URBAN DRAINAGE AND FLOOD CONTROL DISTRICT

UDFCD Maintenance Eligibility Program Referral Review Comments

Project: **Trails at Crowfoot Filing No. 1**
Stream: **Lemon Gulch**
UDFCD MEP Phase: **Design**
UD MEP ID: **106481**

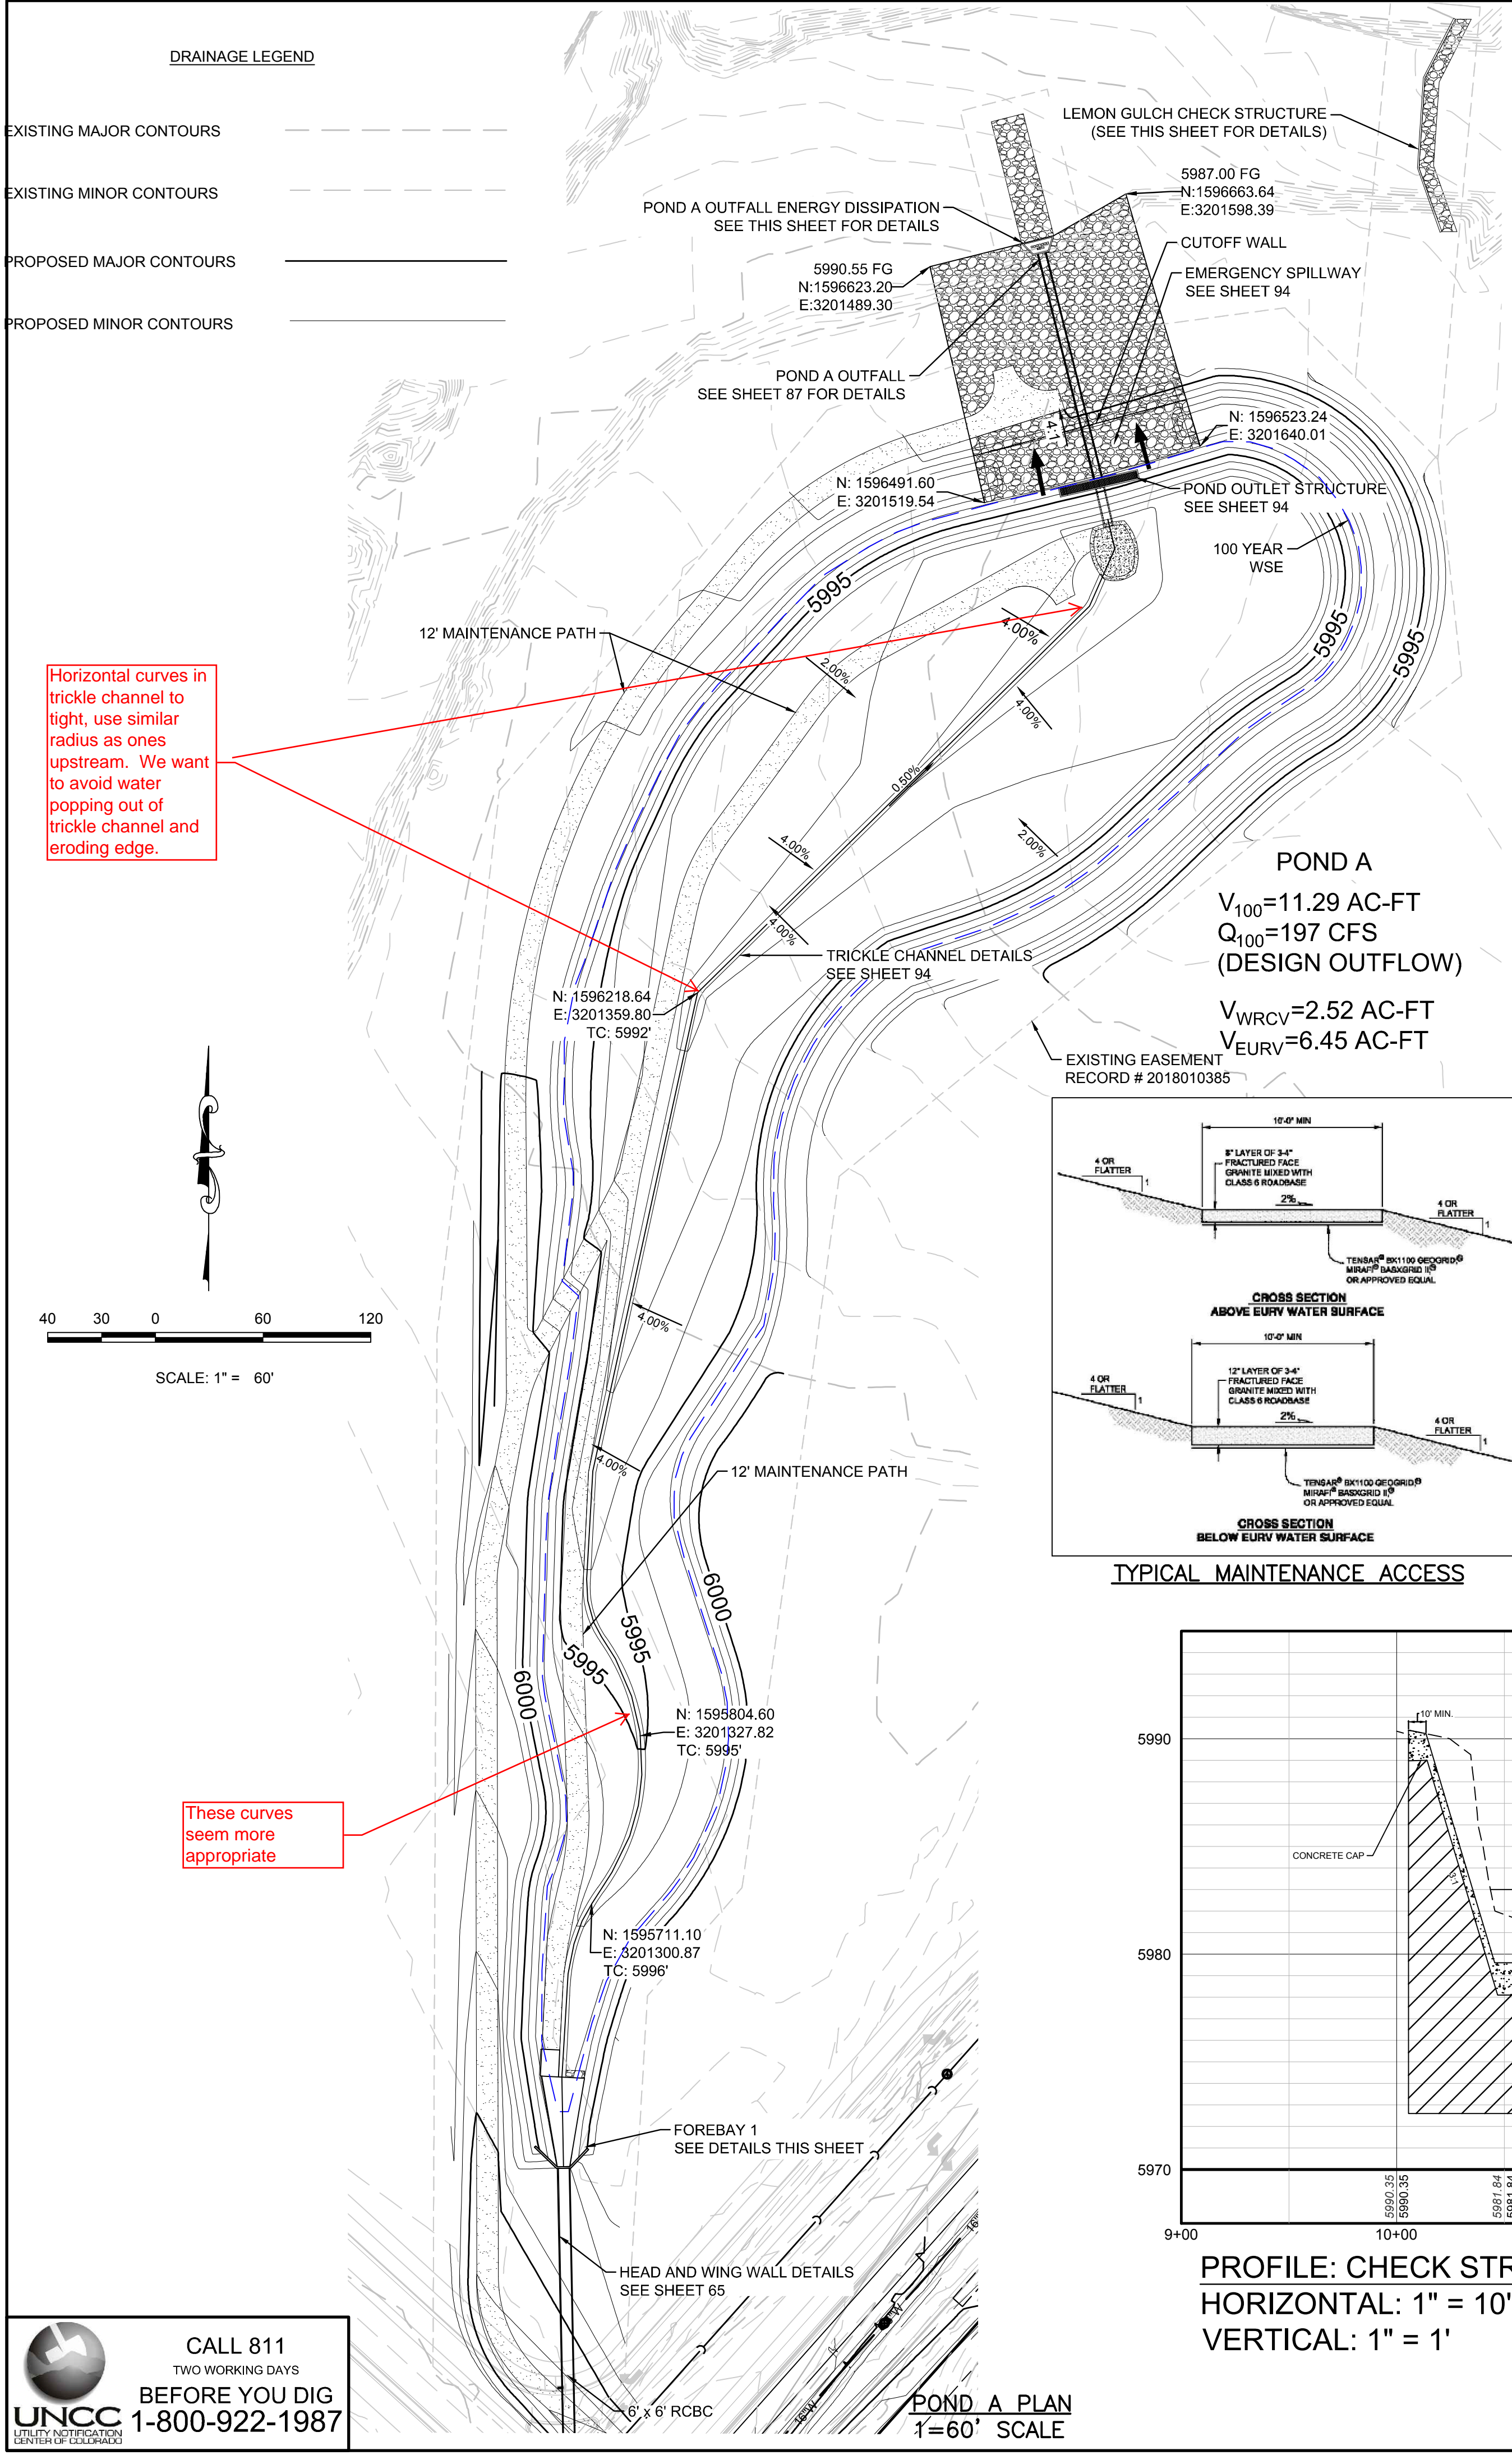
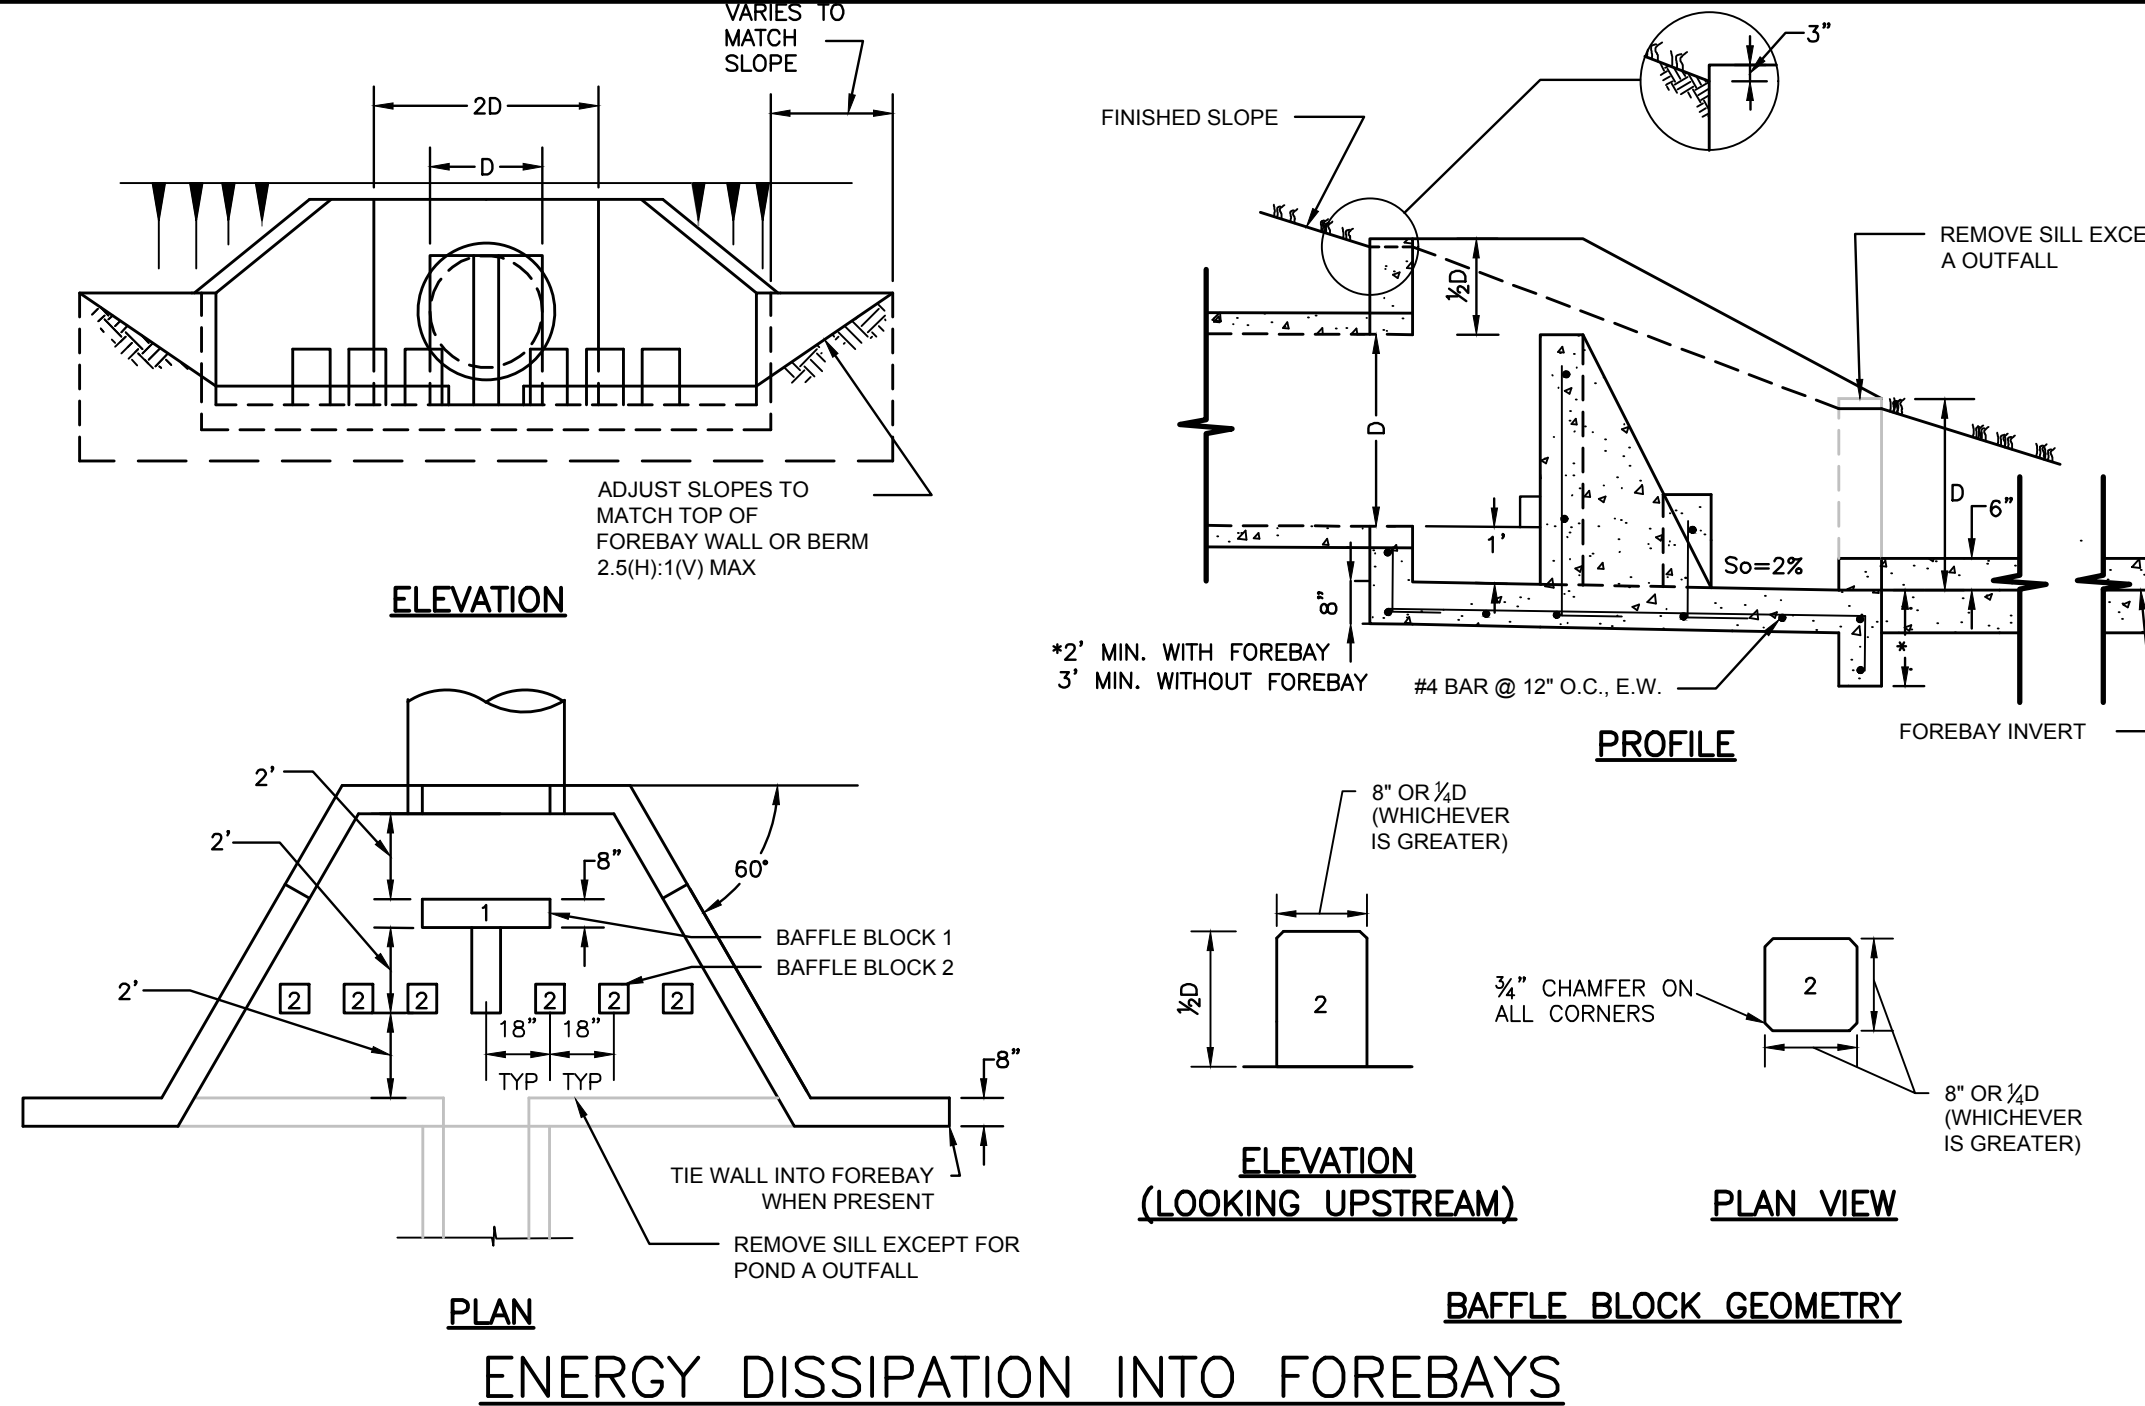
Horizontal curves in trickle channel to right, use similar radius as ones upstream. We want to avoid water popping out of trickle channel and eroding edge.

These curves seem more appropriate

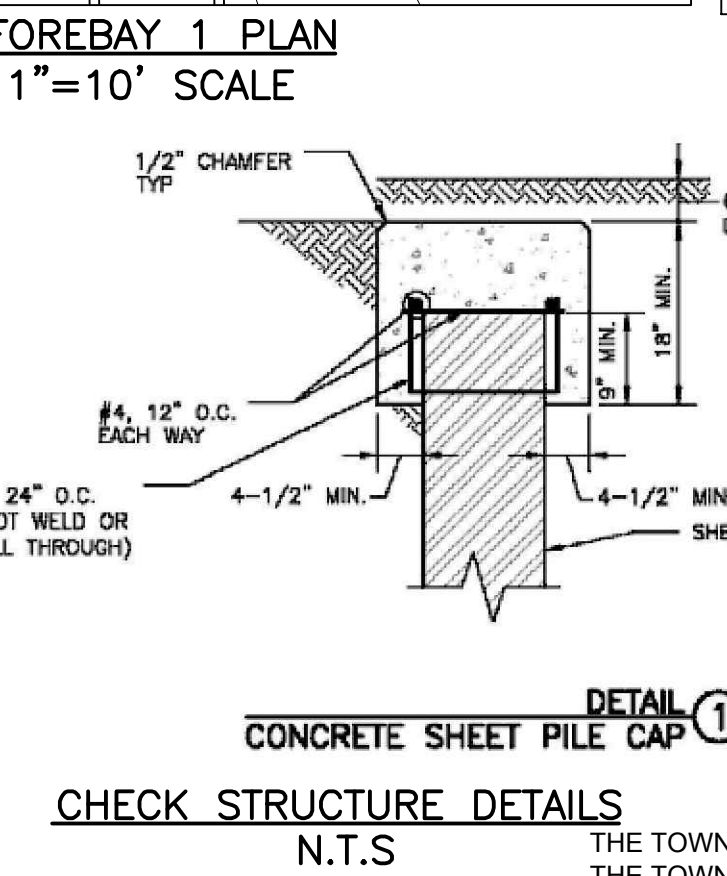
Add low flow notch in center of check. Should be a little less than the 2-year flow in Lemon Gulch.

POND A STAGE-STORAGE CURVE

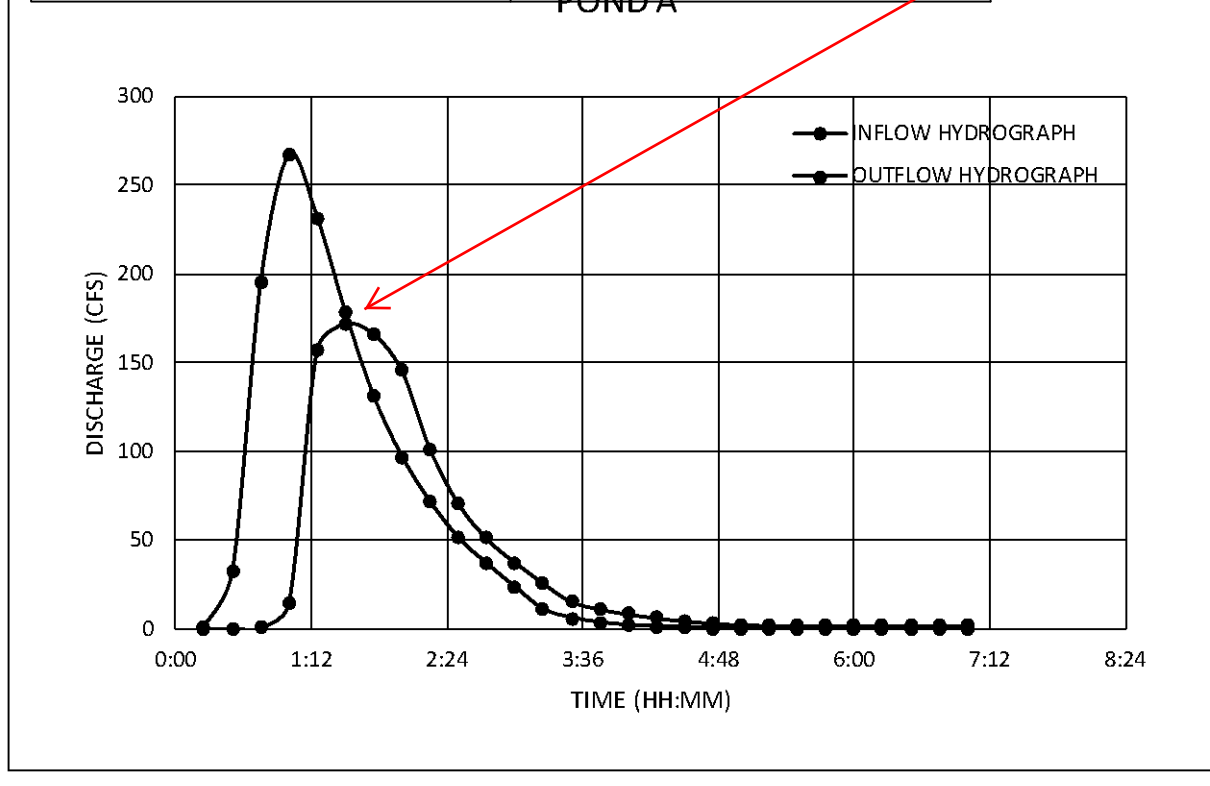
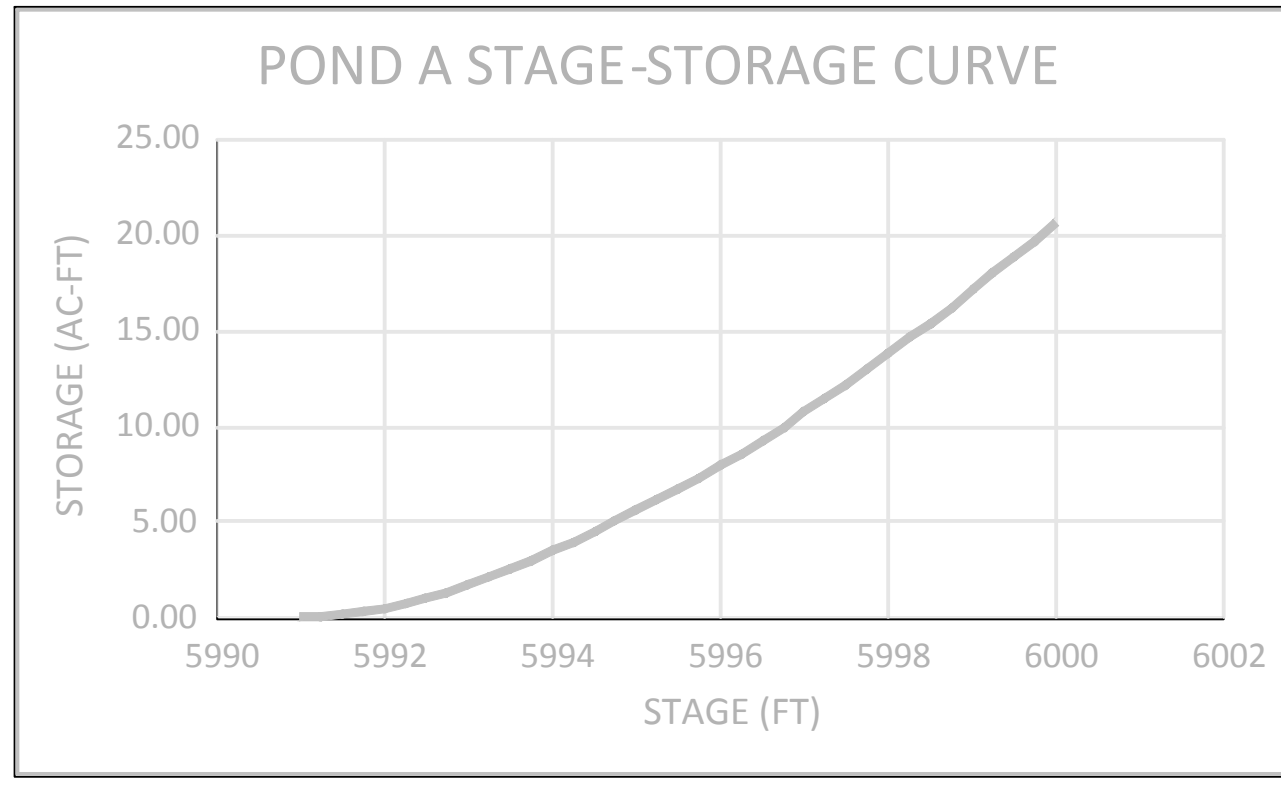
Outflow from UD Detention lists 197.0
